**ZONING MAP CHANGE
STAFF REPORT**

Request: From: "G" Intensive Commercial/I-35 Overlay
To: "PD/D" Planned Development for all uses in "D" High Density Multifamily with a maximum of 118 units; site plan included/I-35 Overlay

ZC-16-073

PD ZONING SITE PLAN

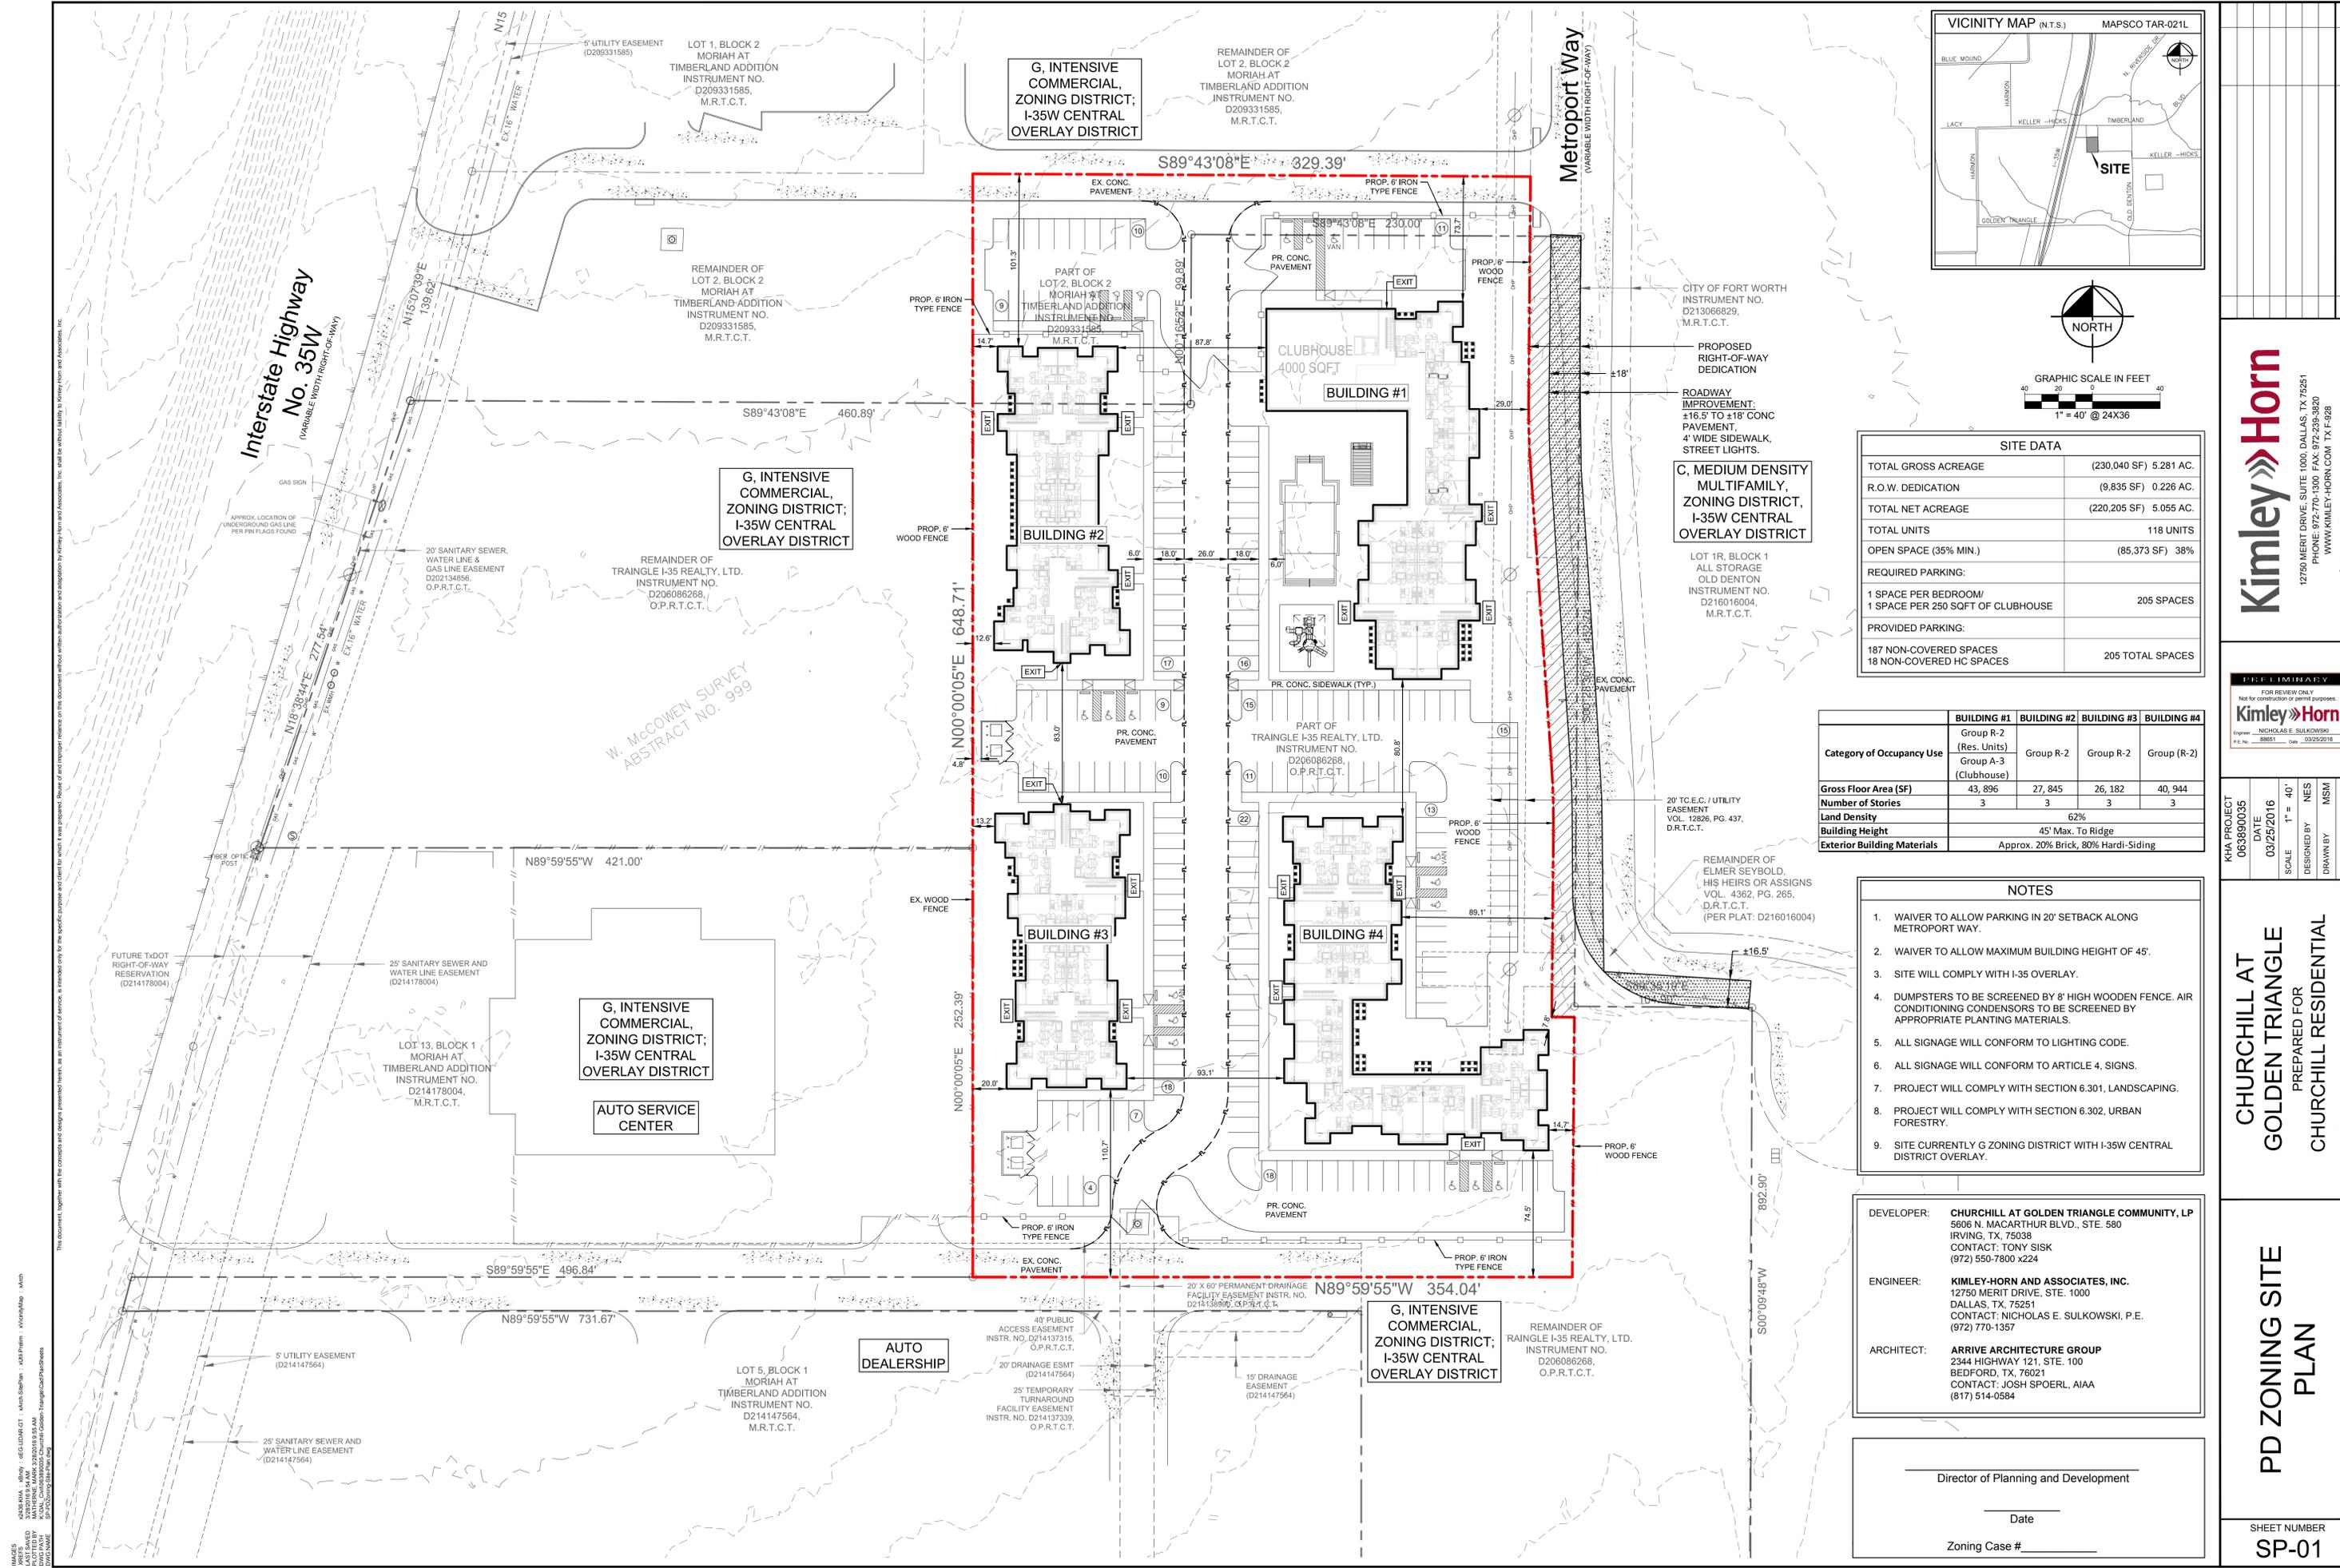
The site plan as submitted is not in general compliance with the Zoning Ordinance regulations. The deficiencies are:

1. 20 ft. setback along Metroport Way
 - a. Parking prohibited (**waiver required**)
2. Provide note stating site will comply with I-35 overlay
 - a. 50 ft front yard setback (**waiver required**)
 - b. 25 ft. front yard paving setback along Metroport (**waiver required**)
 - c. Wood screening fence in Overlay (**waiver required**)
3. Max height of 32 ft. (**waiver required for 45 ft.**)

1. Traffic Impact Study - Submit a Traffic Impact Study (TIS) for TPW approval. The most recent study 3/25/15 does not include multi-family within the uses. A technical update of the TIA will be required in conjunction with the replat. FS-15-269 as it incorporates this portion of a lot.

2. Public Access Easement - Access easements shall comply with the requirements of Section 31-106 (Street Standards) I (Access Easement Design Standards (Public Access Easements, Reciprocal access Easements, Private Drives or Ways) of the Subdivision Ordinance. Access easements are privately maintained but constructed to city street standards that are open to unrestricted and irrevocable public access and serve two or more lots each having a minimum of 100 feet of frontage as their primary means of access. The proposed multi-family site includes a portion of a public access easement, however, does not provide the remaining portion of the lot to have public access achieved for it. Show how the public access easement to the south of the project will continue to connect back to Metroport.

3. Variable ROW - Show the full ROW widths for all existing streets. For streets having variable ROW, call out the ROW as "Variable" and give "Range" of the ROW. Show the widths of Metroport Way and the existing public access easements.

4. Gated Entrances (Ch. 31-107) - Gated entrances into secured areas must be designed in accordance with TPW's "Traffic Engineering Design Standards and Policy Guidelines". Provisions for an acceptable turnaround must be made. Provide details in IPRC plan set (single-family) or UR site plan (multi-family) for gates. All gates shall be equipped with a knock-box or other approved fire access apparatus that is reviewed and approved by the Fire Department. (Gates must be located 3 vehicle lengths from the ROW).

5. Sidewalks - Sidewalks and street lights are required for all public and private streets and public access easements as per City of Fort Worth Standards. Show the sidewalks along Metroport and the public pedestrian access easements proposed on the plat.

1. The 26' fire lane shown on this site plan will need to be named and platted for addressing and identification requirements per the fire code.
2. Show the FDC connections for the buildings. FDC connections are required to be within 50' of a fire apparatus access road (fire lane or street) and within 300' of a fire hydrant. Building's FDC connect must comply with section 912 of the Fire Code

Compliance with the items noted above shall be reflected on the site plan.
